Sun Visor May Move from the Stowed Position

Service Category Vehicle Interior

Section Interior Panels/Trim

YEAR(S)	MODEL(S)	ADDITIONAL INFORMATION
2010 – 2013	Highlander	Plant Code(s): S WMI(s): 5TD

Figure 1.

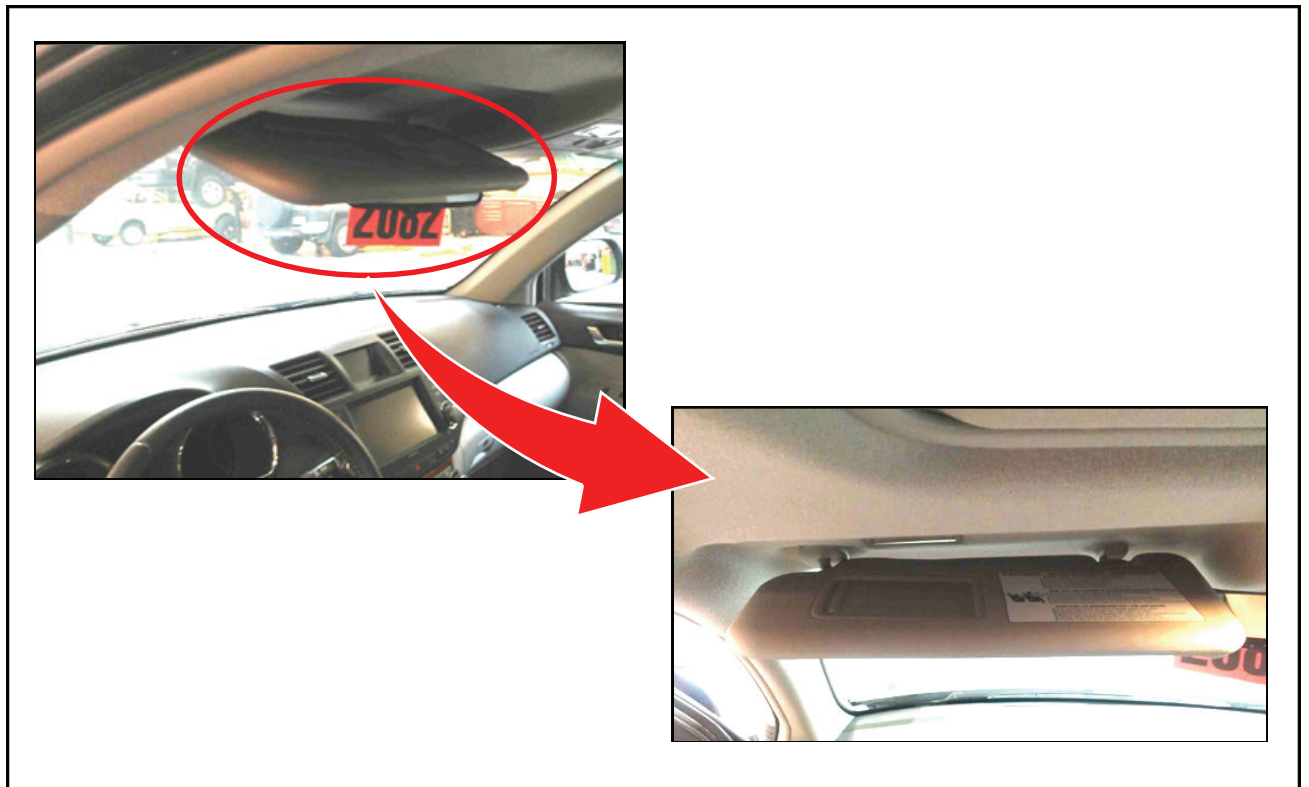
Some 2010 – 2013 model year Highlander vehicles may exhibit a condition in which the driver side or passenger side Sun Visor may move from the stowed position, or may not completely stow flush against the headliner. Follow the Repair Procedure in this bulletin to address this concern.

PART NUMBER		PART NAME	QTY
PREVIOUS	NEW		
74320-0E040-B0 74320-0E041-B0	74320-48170-B1	Visor Assembly, LH	1
74320-0E040-E0 74320-0E041-E0	74320-48170-E1		1
74320-0E050-B0 74320-0E051-B0	74320-48180-B1		1
74320-0E050-E0 74320-0E051-E0	74320-48180-E1		1

PART NUMBER		PART NAME	QTY
PREVIOUS	NEW		
74310-0E040-B0 74310-0E041-B0	74310-48130-B1	Visor Assembly, RH	1
74310-0E040-E0 74310-0E041-E0	74310-48130-E1		1
74310-0E050-B0 74310-0E051-B0	74310-48140-B1		1
74310-0E050-E0 74310-0E051-E0	74310-48140-E1		1

1. Confirm the condition described in the Introduction is present.
2. Replace the Sun Visor.
